SUBJECT: DRAFT RESPONSES TO QUESTIONS GENERATED DURING THE
JULY 29, 1987 MEETING OF THE ACRS SUBCOMMITTEE ON
WASTE MANAGEMENT WITH DOE AT LAS VEGAS, NV

RESPONSE TO QUESTIONS GENERATED DURING THE JULY 29, 1987, MEETING OF THE ADVISORY COMMITTEE ON REACTOR SAFEGUARDS (ACRS) SUBCOMMITTEE ON WASTE MANAGEMENT, THE STATE OF NEVADA NUCLEAR WASTE PROJECT OFFICE, AND THE NEVADA NUCLEAR WASTE STORAGE INVESTIGATIONS (NNWSI) PROJECT

Enclosure 1

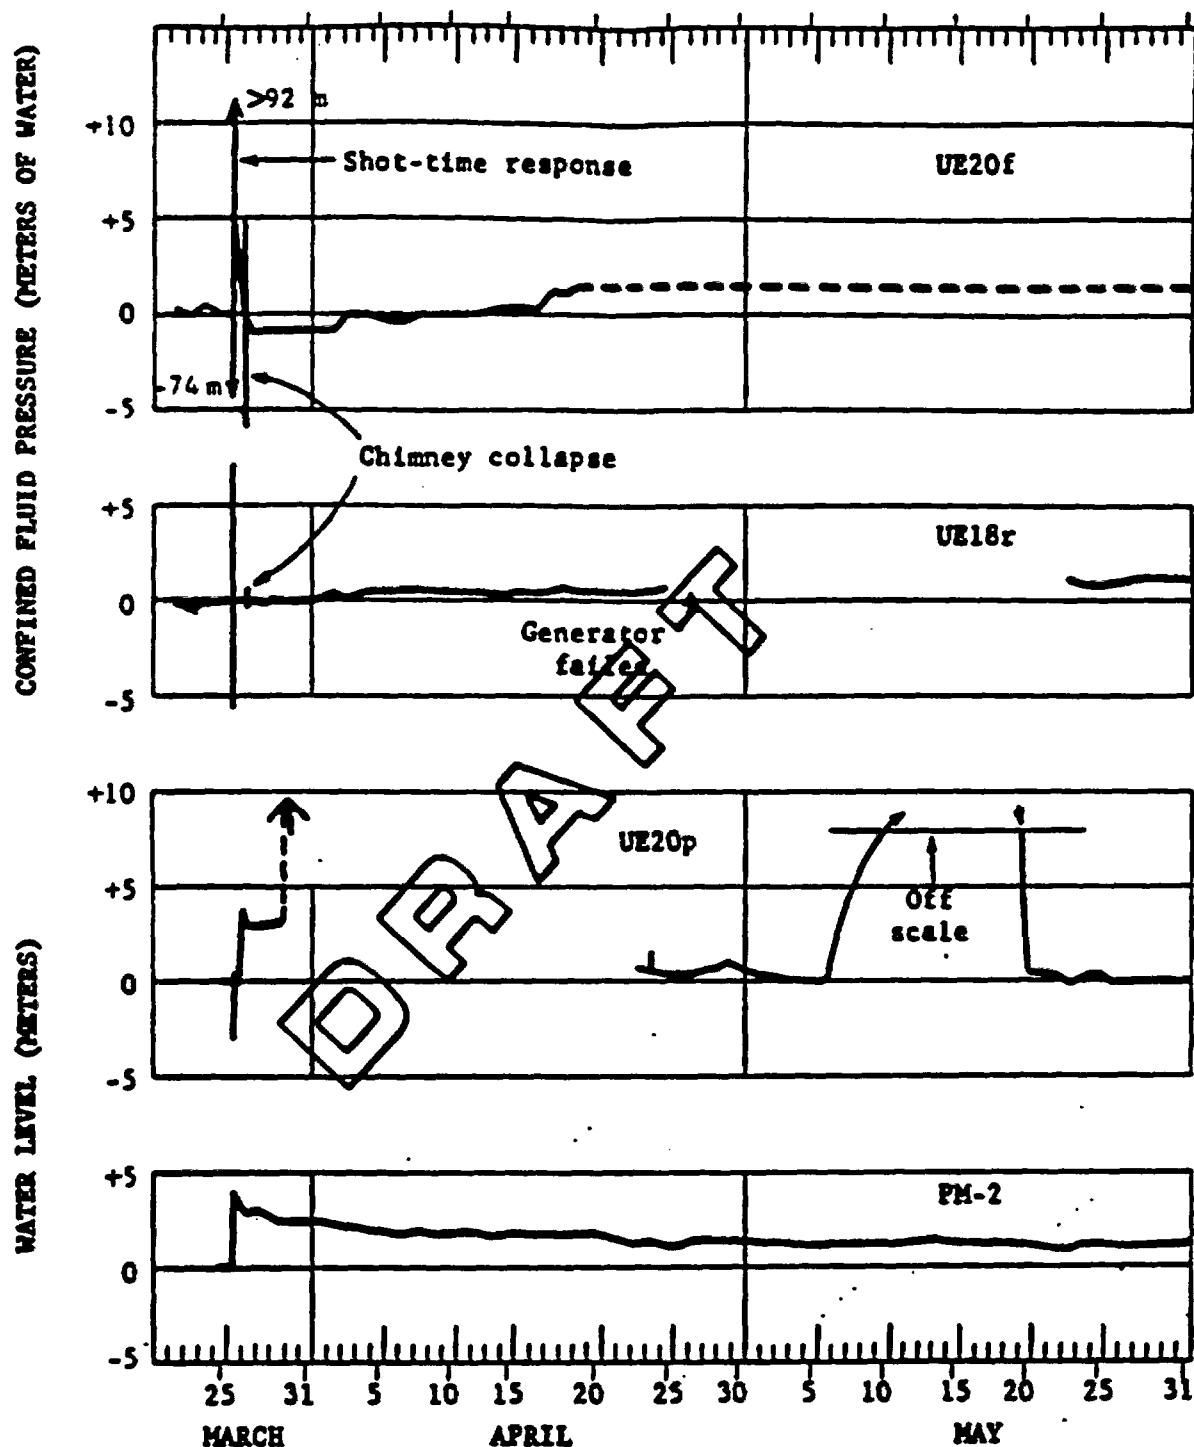
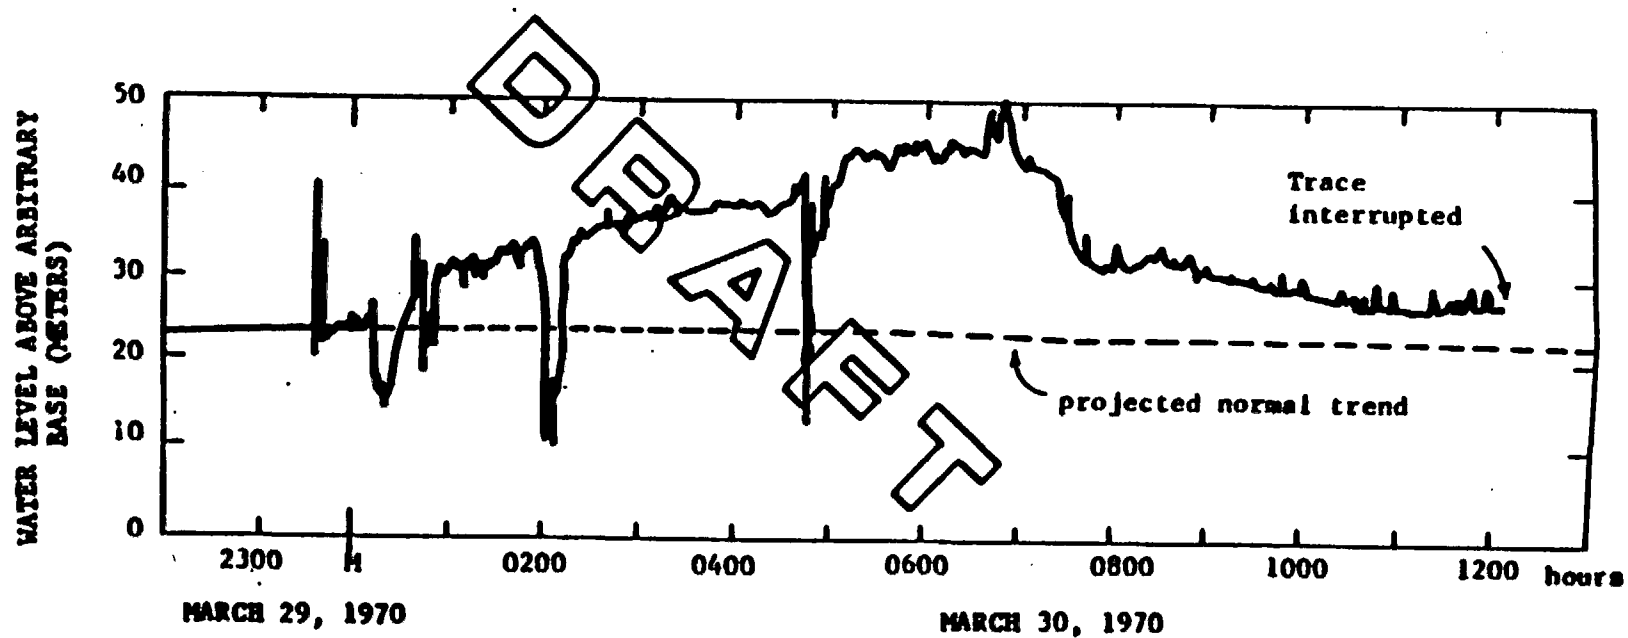
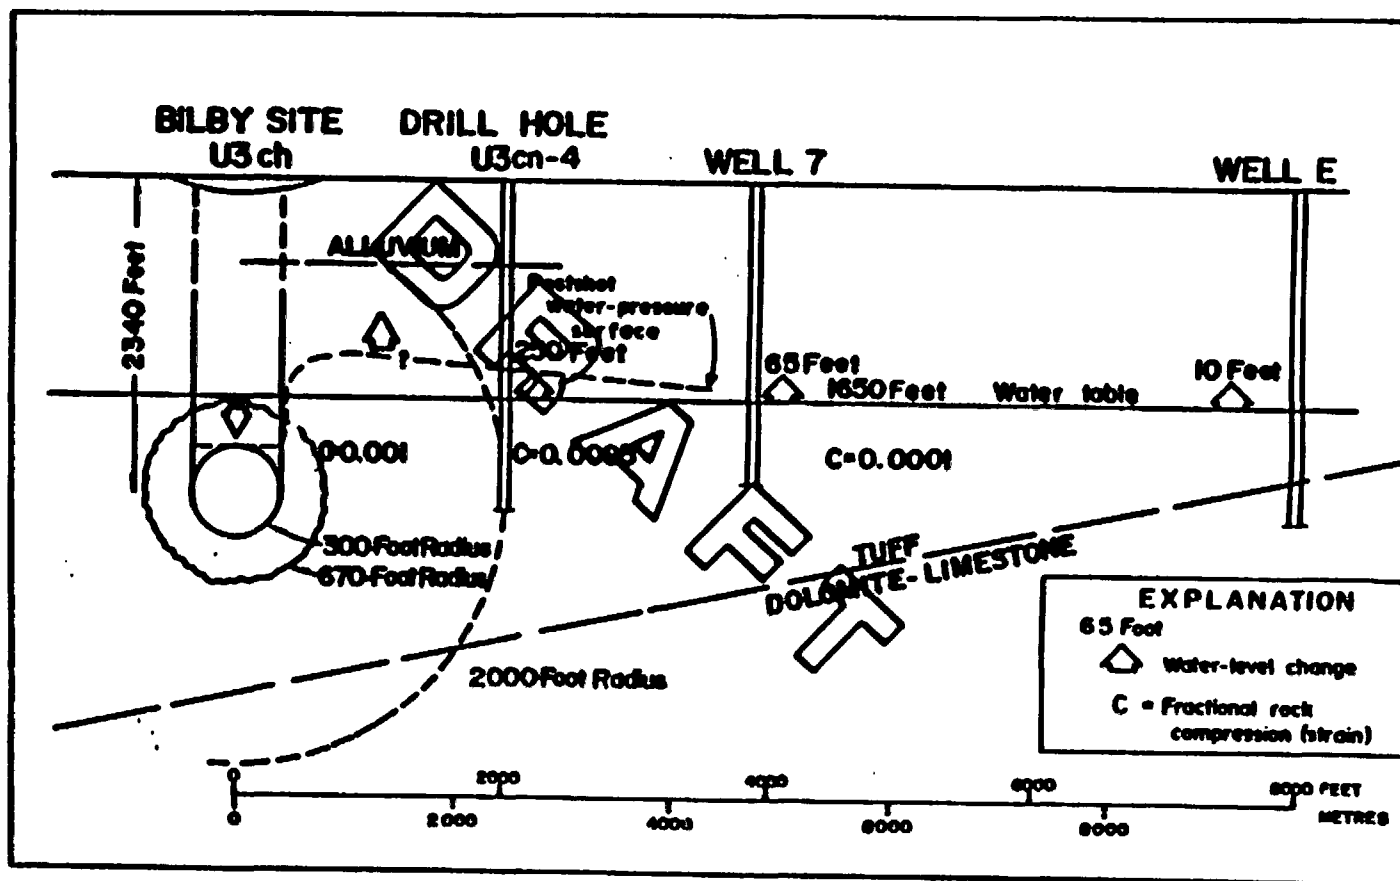
Question 3: Provide information regarding water table fluctuations induced by underground nuclear explosions.

ACRS Statement of the Question: Indications are that the underground nuclear weapons tests have altered (temporarily and/or long range) the water tables in the area. Data on these changes should be provided.

Data exists for wells located near the sites of underground nuclear explosions, however, it is not clear if the observed change in water levels represent increases of the water-table altitude or merely pressure increases in the formation. The following information was taken from an USGS Open File Report 76-313; "1976 Field Trip to Nevada Test Site," p. 45-49.

Fluid-pressure response to several nuclear events has been measured by placing pressure transducers in boreholes, often with the water column confined by inflatable packers. The first effect is an oscillatory pressure response to seismic signals generated by the explosion. The Handley event (March, 1970), an explosion having a yield slightly greater than 1 megaton, produced a dynamic ground-water overpressure of more than 300 feet in drill hole UE20f (fig. 1), about 3 miles from the event site. In Clayton Valley, 71 miles northwest of the Handley site, the oscillatory head change was less than 3 feet but produced surges of more than 100 gpm in some open wells.

Sustained pressure changes, resulting from compaction of the rocks around the explosion and from closing of fractures by seismic stresses, were recorded for more than a month after the Handley event. In drill hole UE20p (figs. 1 and 2), about 3 miles north of the event site, a sustained pressure rise of 164 feet occurred 4 days after Handley.

Similar effects result from the lower yield explosions beneath Yucca Flat. The Bilby event (U3cn) in Area 3 (September, 1963), having a reported yield of approximately 200 kt, caused the fluid level to rise about 250 feet in an observation well, 2,000 feet from the explosion site (fig. 3). It is not known whether these observed water levels represent increases of the water-table altitude or merely pressure increases that dissipate slowly in the relatively impermeable tuffs. In either case, they indicate explosion-caused hydraulic mounds that may be responsible for the surprisingly high water levels found in some exploratory and replacement holes drilled near earlier explosion sites.

While this data exists for the NTS, no data has yet been published concerning the effects of underground nuclear explosions on water level fluctuations or pressure changes at wells near Yucca Mountain. The NNWSI Project recognizes the importance of understanding the hydrologic system and has initiated efforts to analyze and interpret data that has been taken from wells in the vicinity of Yucca Mountain. The Project expects to publish a report entitled "Estimates of Aquifer Characteristics from Water-Level Fluctuations Induced by Earth Tides and Barometric Fluctuations" early next year. In addition, data reports containing water-level data, well and test hole descriptions, pertinent well histories, descriptions of the data collection procedures, and indications of data accuracy and precision will be published periodically as data become available.
